DIESEL PARTICULATE FILTER (DPF) – LOOSE PLUGS

Prevost vehicles

FIRST PLUG

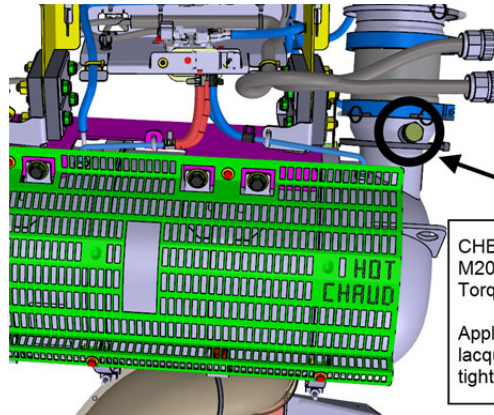
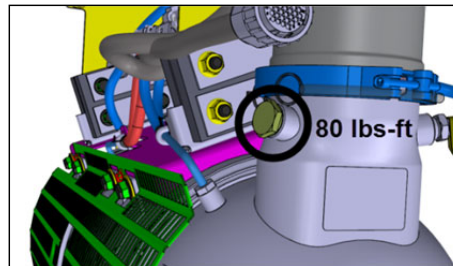
On the vehicles affected by this bulletin, two DPF (diesel particulate filter) plugs may be loose. If a plug is loose, it may fall under the effect of vibration. This may cause leakage of hot exhaust gases.

1. Check if the M20 hexagonal plug located to the right side of the DPF (see image at right) is properly tightened.

2. Apply a torque of **80 lbs-ft**.

Note: Apply torque seal inspection lacquer to certify that tightening has been checked.

CHECK TIGHTENING OF 1/8-27 NPT PLUG. Tighten 2 turns from finger tight (2 T.F.F.T.)

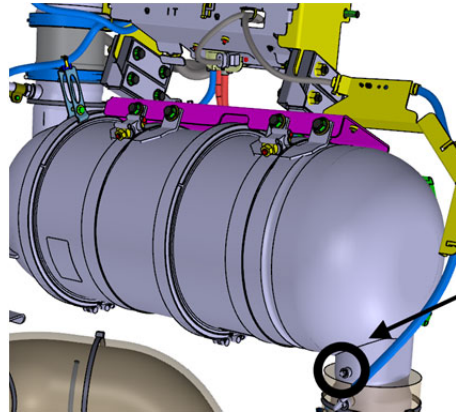
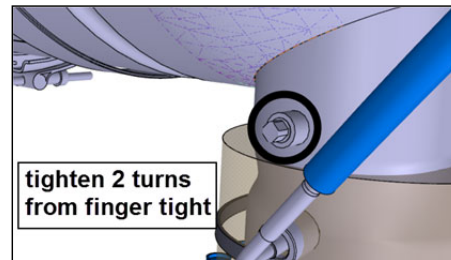
1. Check if the 1/8-27 NPT plug located to the left side of the DPF (at the inlet of DPF) is properly tightened.

2. Tighten 2 turns from finger tight (2 T.F.F.T.).

Note: Apply torque seal inspection lacquer to certify that tightening has been checked.

Note: Copper anti-seize compound can be applied on this particular plug if necessary.

Apply torque seal inspection lacquer to certify that tightening has been checked.
